EXISTING CONDITIONS,
DEMOLITION & TESC PLAN

PROJECT
WHATCOM PHYSICAL THERAPY
FOR
CARLETTI ARCHITECTS
IN A PORTION OF SE 1/4, SECTION 19, TOWNSHIP 39 N., RANGE 2 E., W.M.

CONSTRUCTION RECORD DRAWING

**PROPOSED GRADING,
DRAINAGE & UTILITY PLAN**

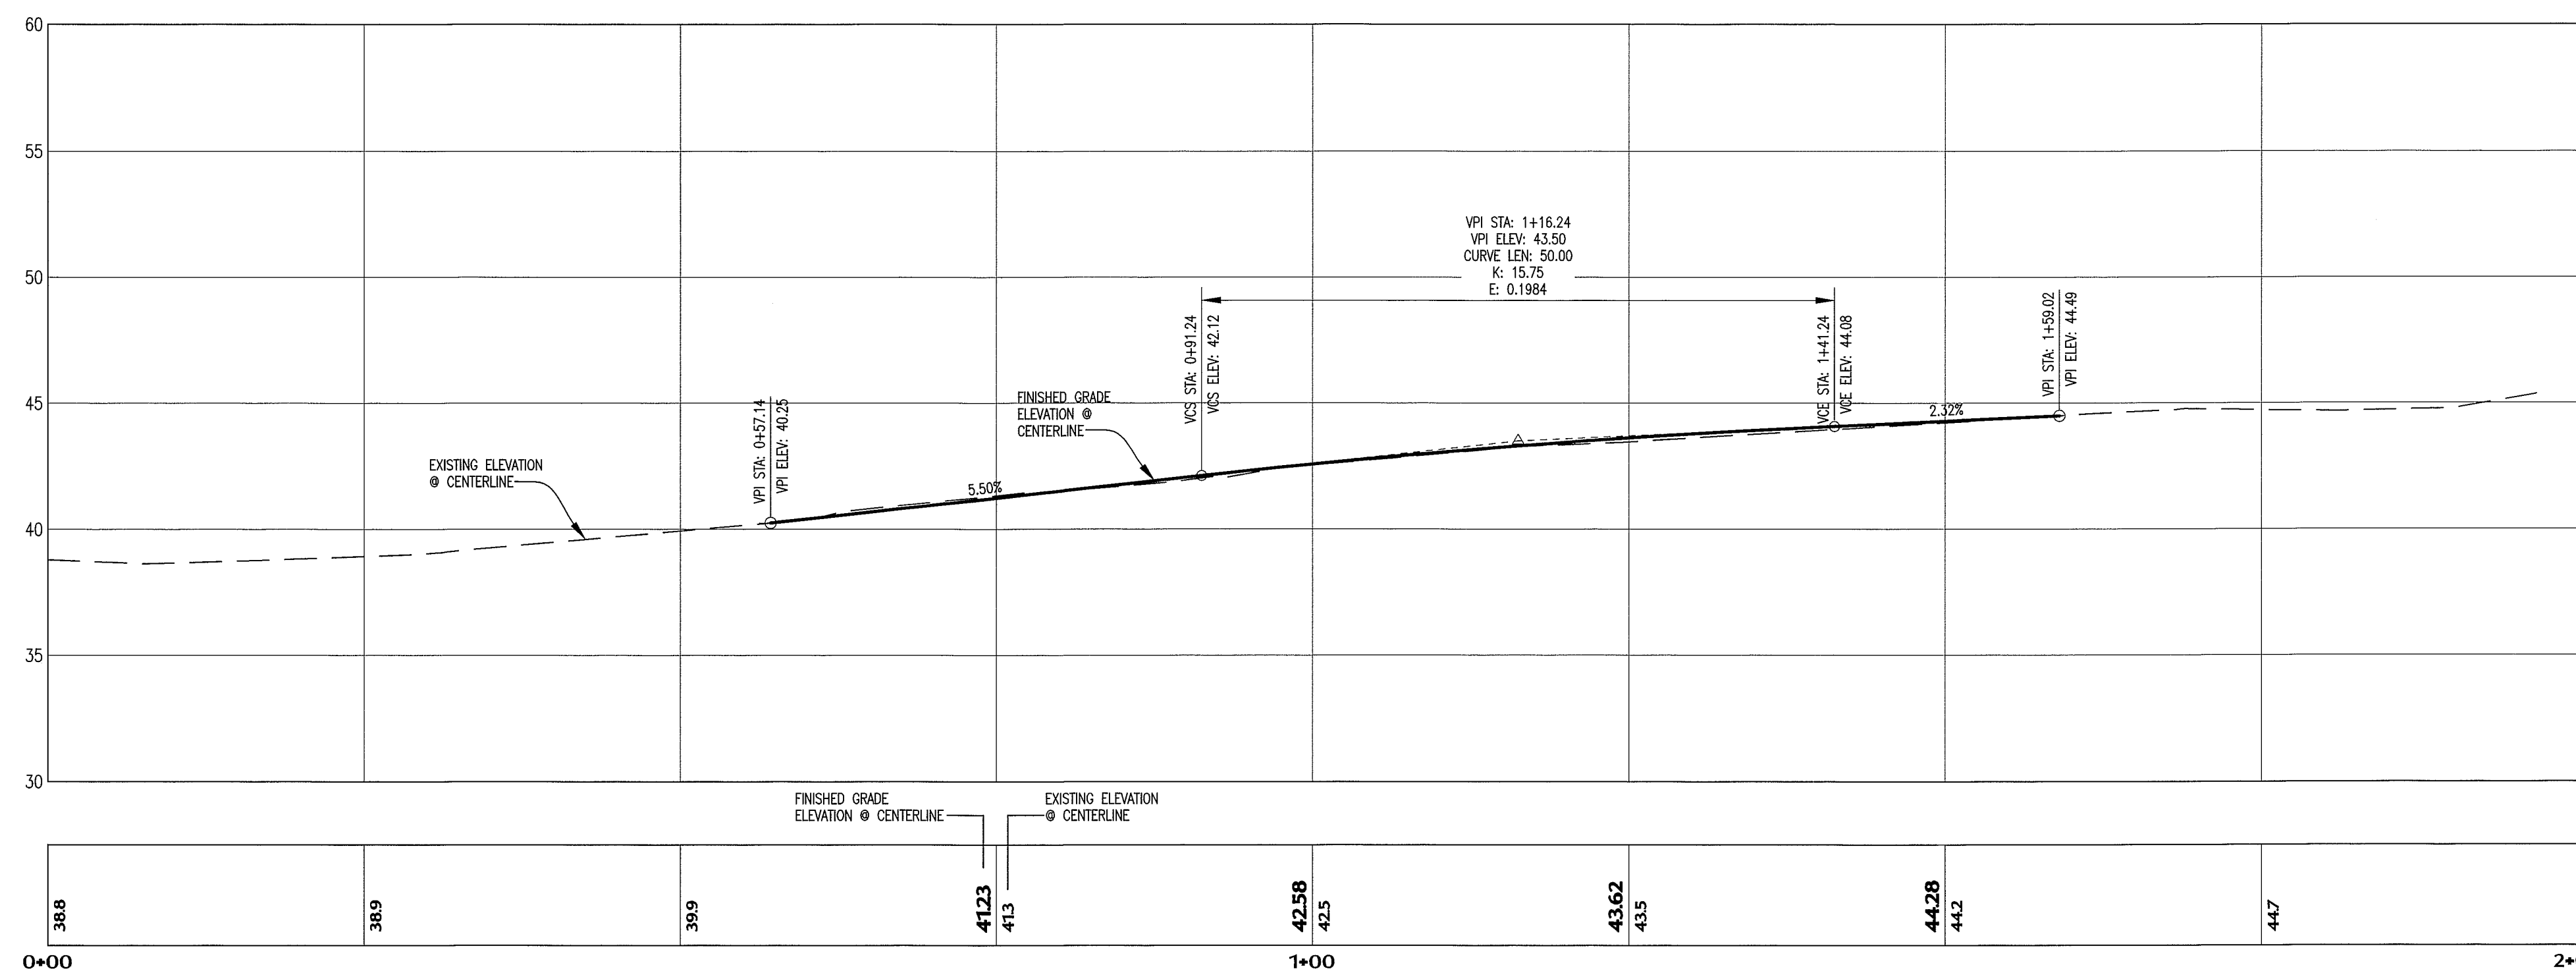
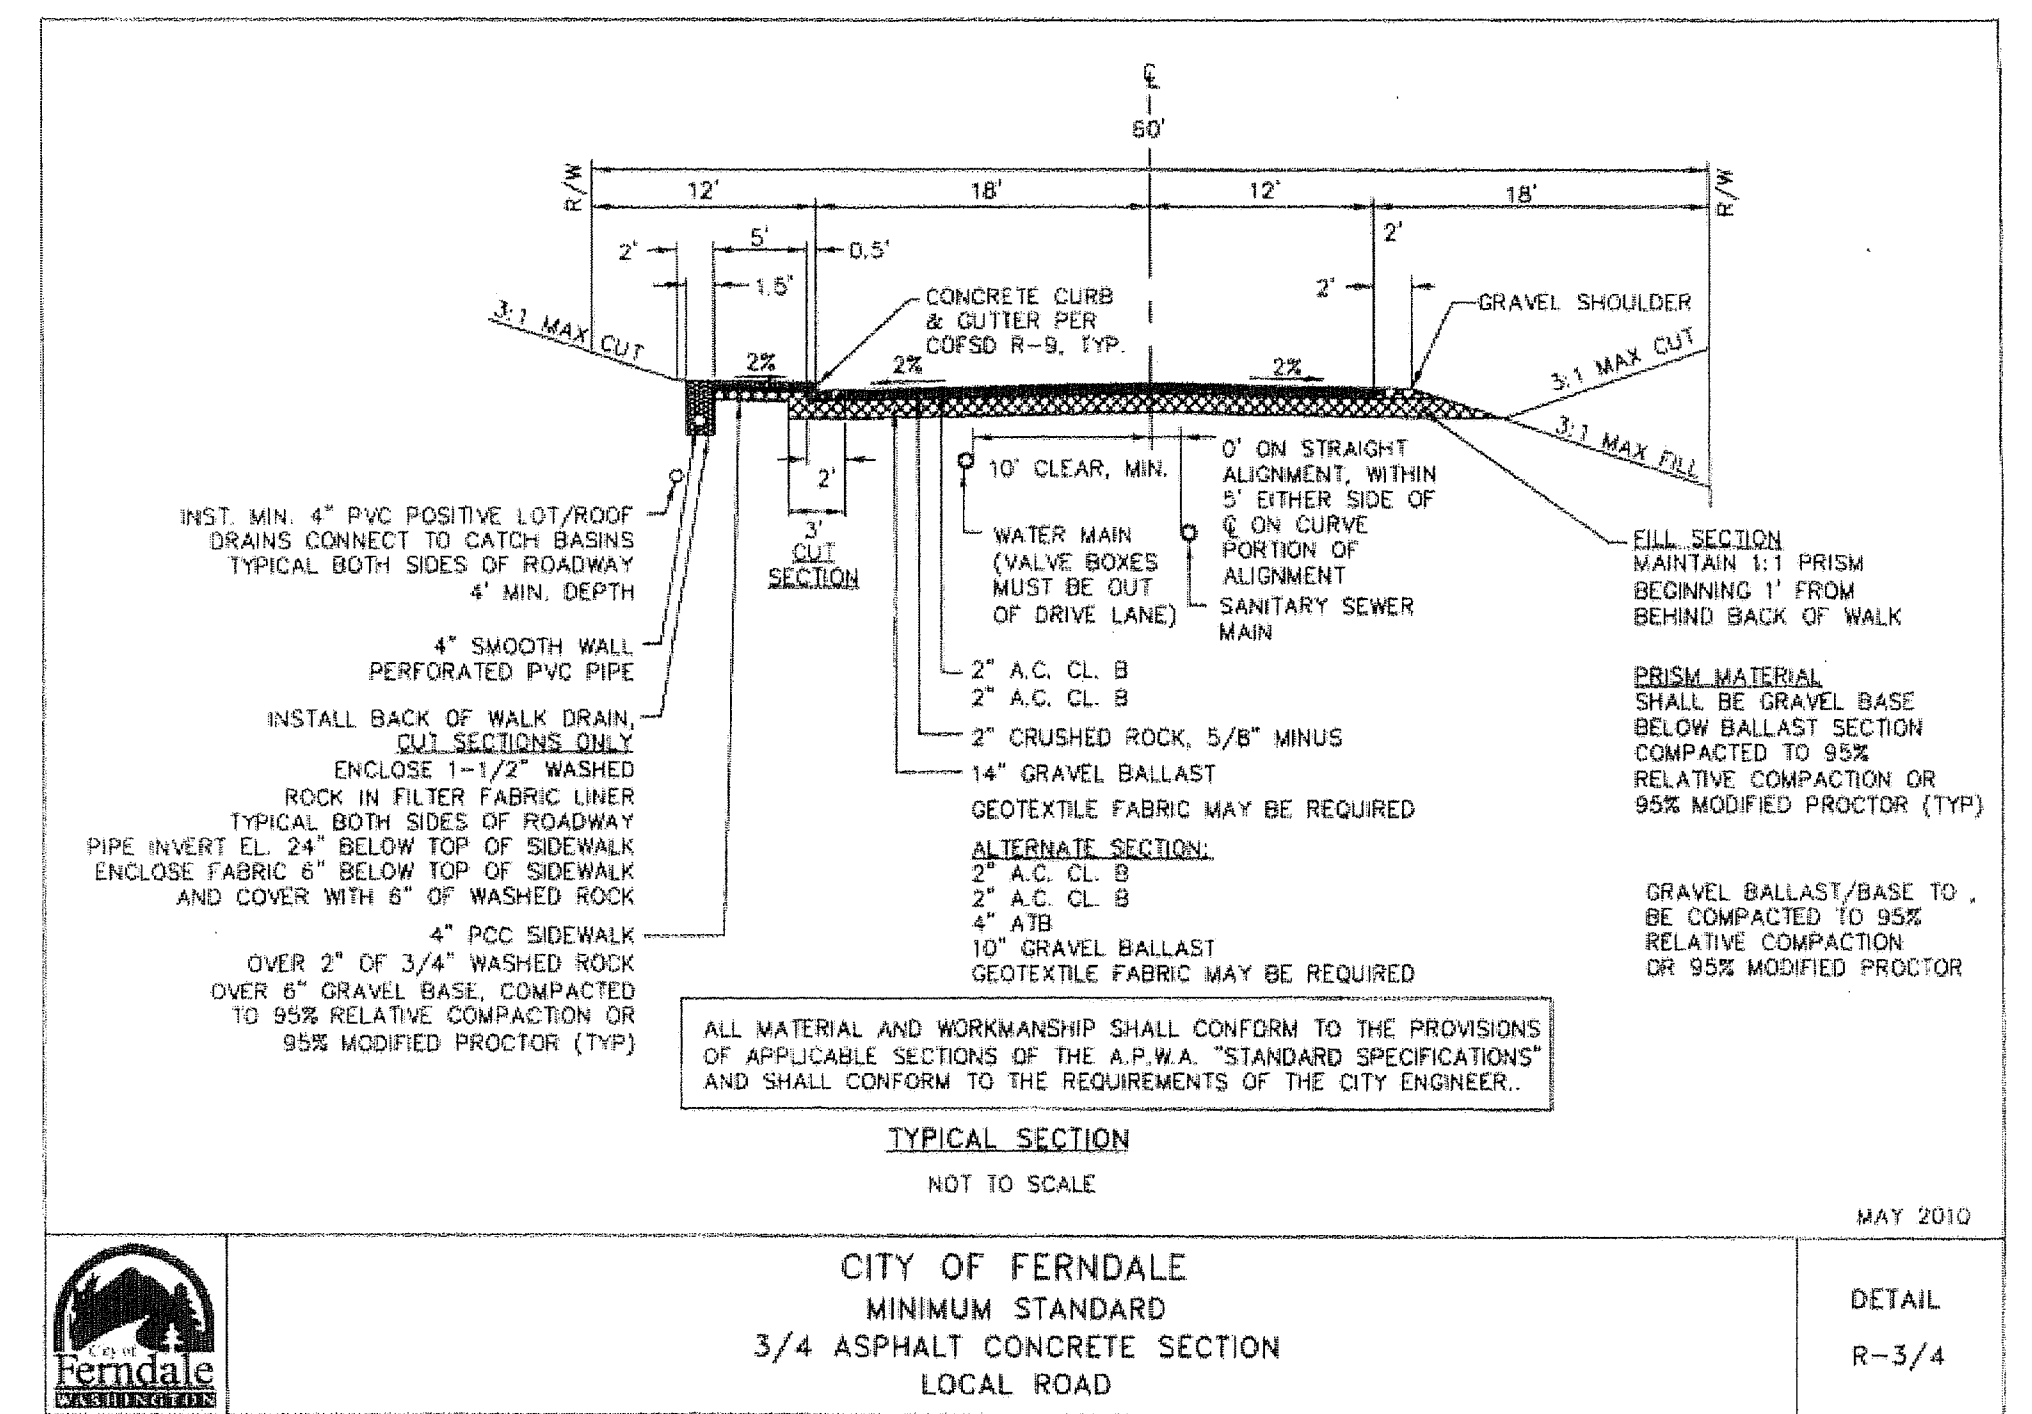
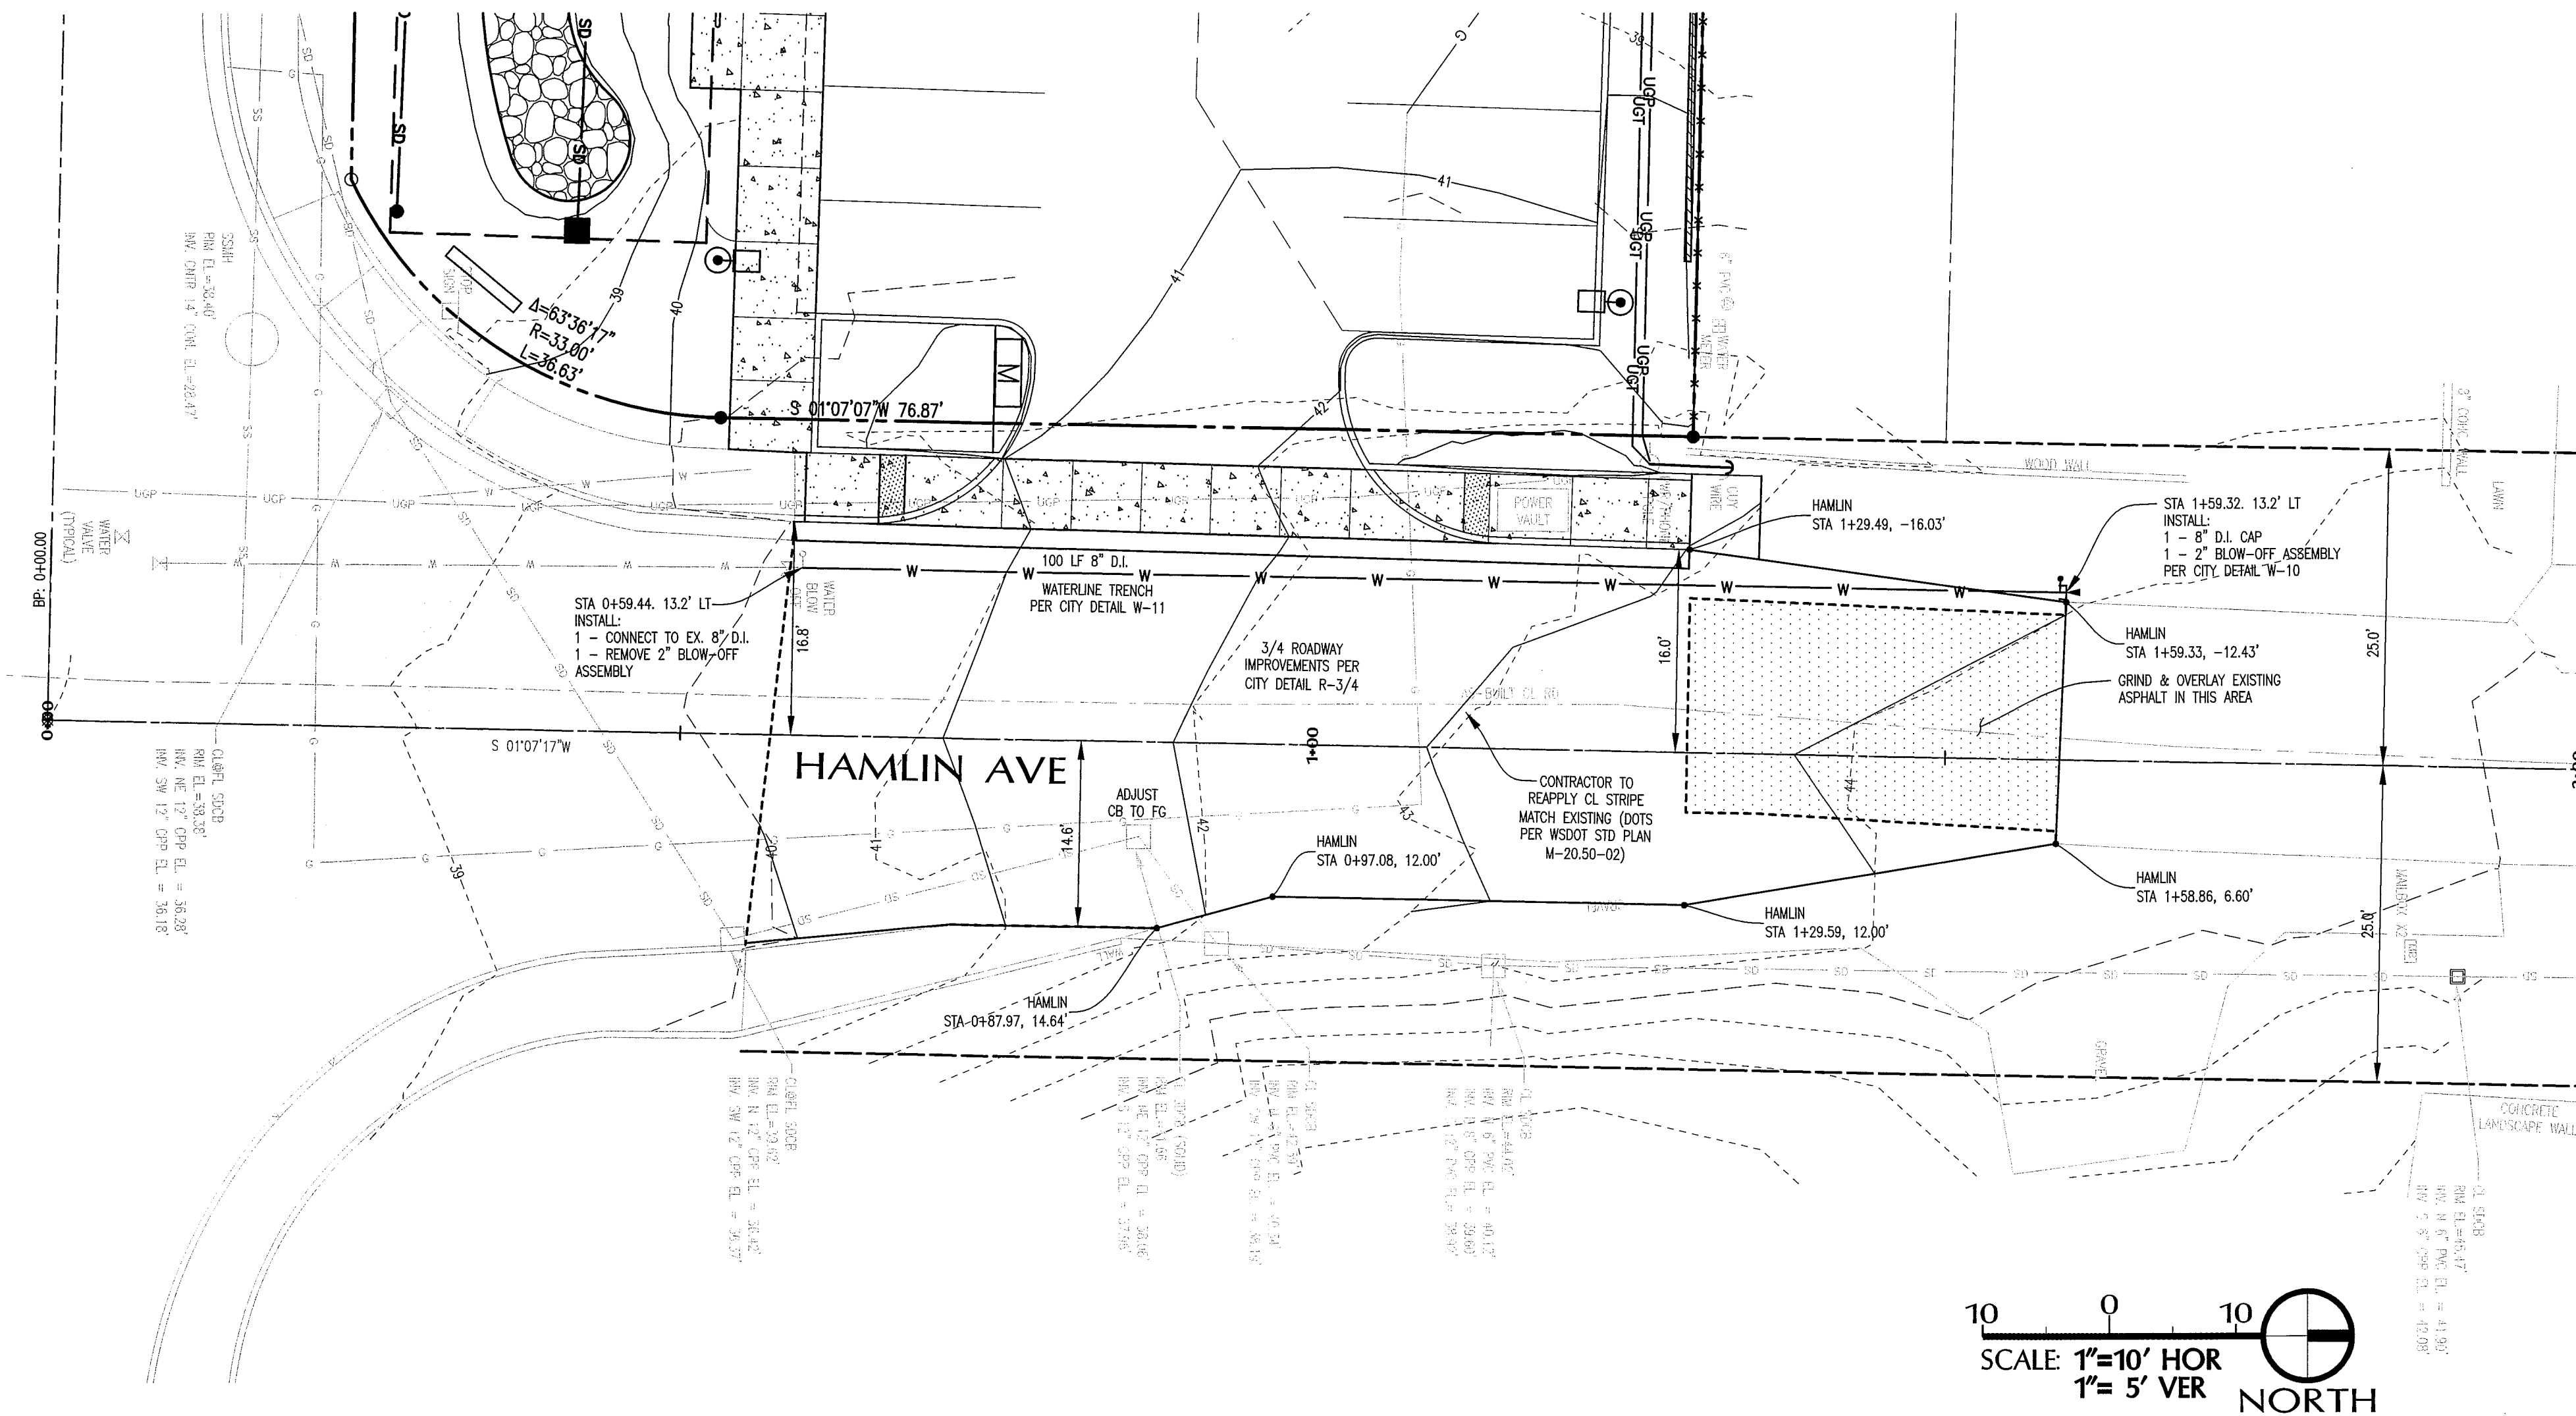
CB#1, TYPE 1 CATCH BASIN, STD GRATE
RIM = ~~39.70~~ 39.78
IE 8" D.I., S = ~~38.21~~ 38.33

CB#2, TYPE 1 CATCH BASIN, STD GRATE
RIM = ~~39.95~~ 40.02
IE 8" P.V.C. SDRSS, S = ~~37.96~~ 38.15
IE 8" D.I., S = ~~37.96~~ 37.93

CB#3, TYPE 1 CATCH BASIN, BEEHIVE, SEE
RAIN GARDEN DETAIL J/5
RIM = ~~38.30~~ 38.53
IE 8" PERF., W = ~~35.40~~ 35.66

CB#4, TYPE 1 CATCH BASIN, THRU GRATE
RIM = ~~38.29~~ 38.33
IE 8" P.V.C. SDRSS, W = ~~35.40~~ 35.63
IE 8" PERF., N = ~~35.40~~ 35.59
IE 8" PERF., E = ~~35.40~~ 35.65

CB#5, TYPE 1 CATCH BASIN, STANDARD TOP
RIM = ~~39.80~~ 39.86
IE 8" P.V.C. SDRSS, W = ~~36.30~~ 36.87
IE 8" P.V.C. SDRSS, E = ~~35.22~~ 35.82
IE 8" P.V.C. SDRSS, N = ~~35.22~~ 35.86
